This letter is to inform you that Cree will establish an alternate assembly and test facility for its RF components. This notification is for your information and concurrence.

DESCRIPTION OF DESIGN AND/OR PROCESS CHANGE

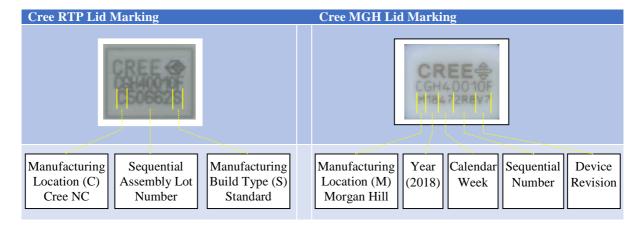
The appearance of devices manufactured will look different, only in the lid marking and lot number format.
